AIRAC
AIP
Supplement 29/25
6 MAR 2025

A D : MUAN/Muan INTL(RKJB)

RWY 19 THRESHOLD DISPLACED BY 300 m

(Effective : 1600UTC 16 APR 2025)

4. DIAGRAM

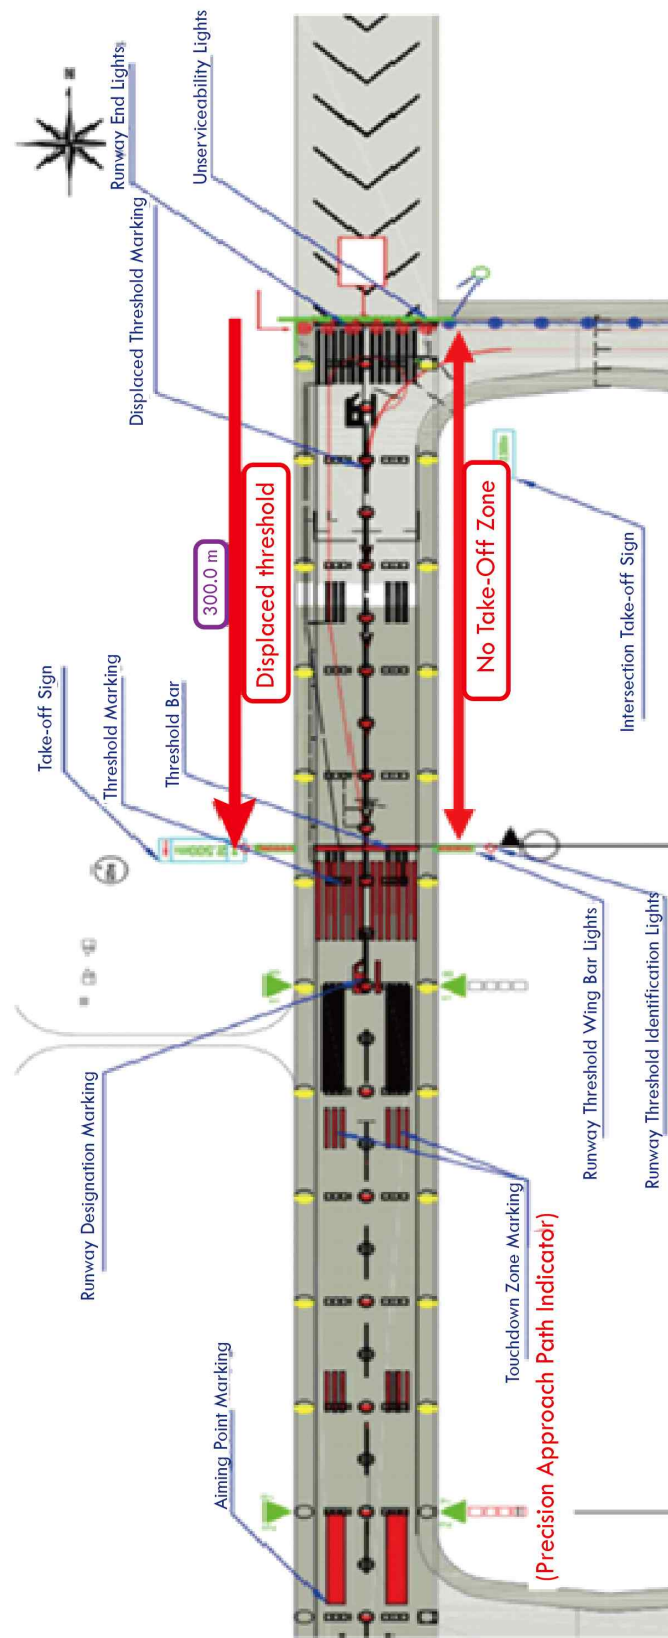
RWY 19 landing threshold will be displaced by 300 m.

- (1) Temporary sign for TORA 2 500 m and intersection take-off sign when entering RWY 19 from TWY E1 will be installed.
- (2) To avoid aircraft blast, all departure aircraft for RWY 19 shall start take-off at displaced threshold("T" point).
- (3) Any change to the contents of these pages will be notified by NOTAM.
- (4) TDZL will be U/S.
